# Work Order ID 87293

Item Name: Crosstube Aft

DART AEROSPACE LTD		Work Order:	87293
Description: Crosstube High Aft (412)		Part Number:	D412-664-203
Inspection Dwg: D412-664-243 Rev: E		Page 1 of 1

DRAWING NO. D412-664-243	TITLE CROSSTUBE ASSEMBLY (412 HI AFT)	REV. E	DART AEROSPACE LTD ENGINEERING ORDER		D.E.O. NO. D412-664-243-E-1	SHEET NO. SHEET 1 OF 2	SCALE NTS
DRAWN	CHECKED	MFG. APPR.	APPROVED		DE APPR.		
DATE 11.03.31	DATE 11/03/31	DATE 11.03.31	DATE 11/03/31		DATE 11.03.31

DRAWING NO. D412-664-243	TITLE CROSSTUBE ASSEMBLY (412 HI AFT)	REV. E	DART AEROSPACE LTD ENGINEERING ORDER	D.E.O. NO. D412-664-243-E-1	SHEET NO. SHEET 2 OF 2	SCALE NTS
DRAWN	CHECKED	MFG. APPR.	APPROVED	DE APPR.		
DATE 11.03.31	DATE 11.03.31	DATE 11.03.31	DATE 11.03.31	DATE 11.03.31

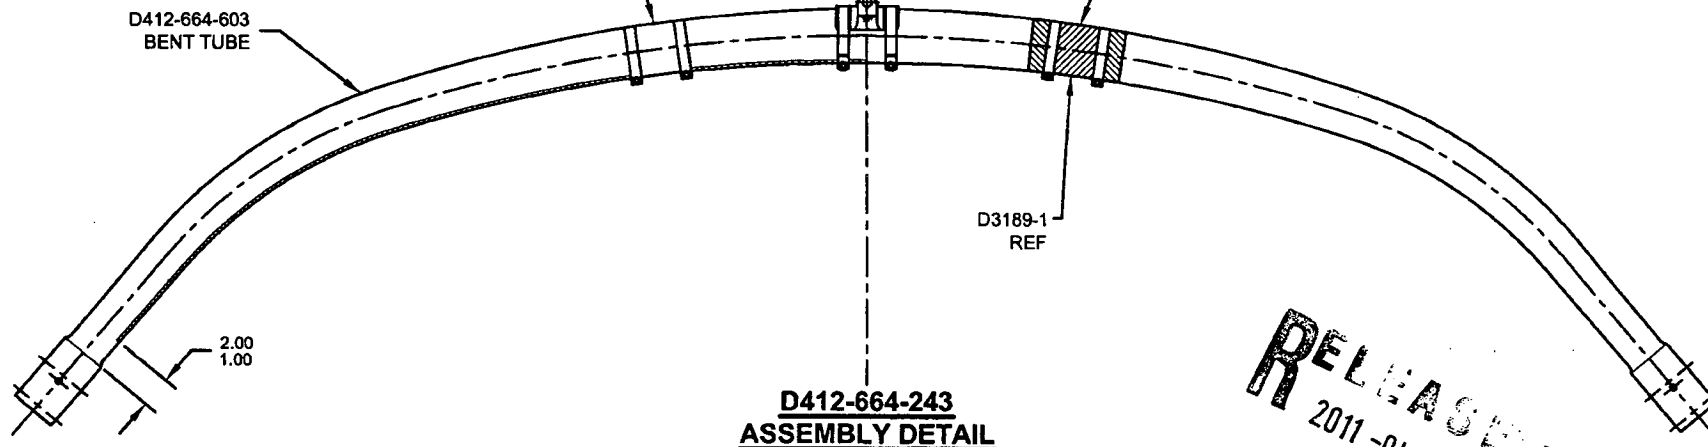
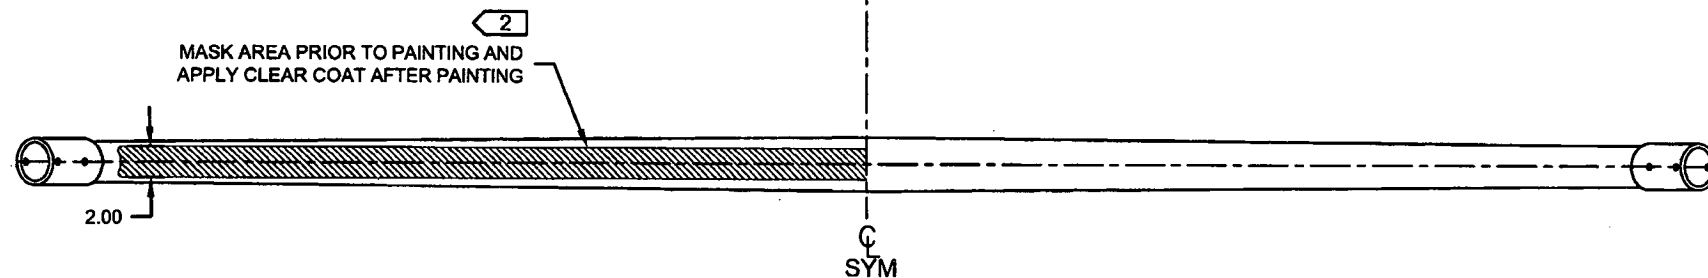
REMOVED ABRASION STRIP IN FAVOR OF A THIN LAYER OF PROSEAL 890.

**IS:**

D3189-1 CHAFING SHIELD (1, INSTALLED OVER PROSEAL 890)  
MS21920-28 CLAMP, 2X  
2 PL

**WAS:**

D2856-600-1009 ABRASION STRIP  
D3189-1 CHAFING SHIELD (1, INSTALLED OVER ABRASION STRIP)  
MS21920-28 CLAMP, 2X  
2 PL

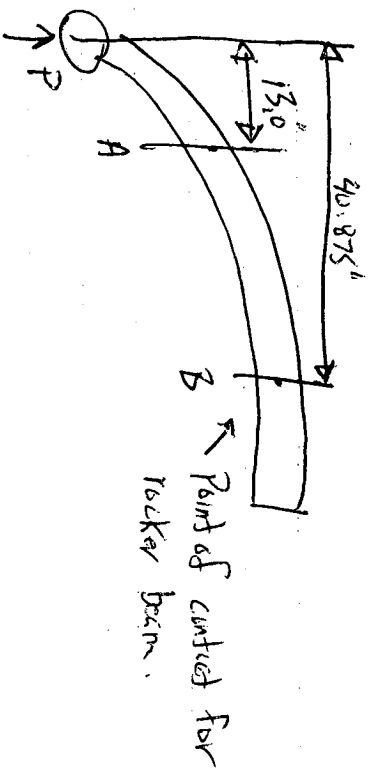
REPLACE MAGNOBOND WITH 3M DP460 SCOTCH-WELD EPOXY ADHESIVE

NOTE 12 & 16, SHEET 1 IS AMENDED AS FOLLOWS:

IS:

- 12) INSTALL D2896-1 CENTER SUPPORT USING A 0.04" TO 0.07" THICK LAYER OF SCOTCH-WELD DP460 PER QSI 015. LET CURE FOR 24 HOURS AFTER INSTALLATION AND PRIOR TO PACKAGING.
- 16) TORQUE CLAMPS 80 TO 100 IN-LB. ENSURE AT LEAST 1.5 THREADS SHOWING IN SAFETY AND THAT NUT HAS NOT BOTTOMED-OUT AFTER TORQUING. **PRIOR TO PACKAGING, RE-CHECK TORQUE ON CLAMPS AFTER ADHESIVE HAS CURED FOR 24 HOURS.**
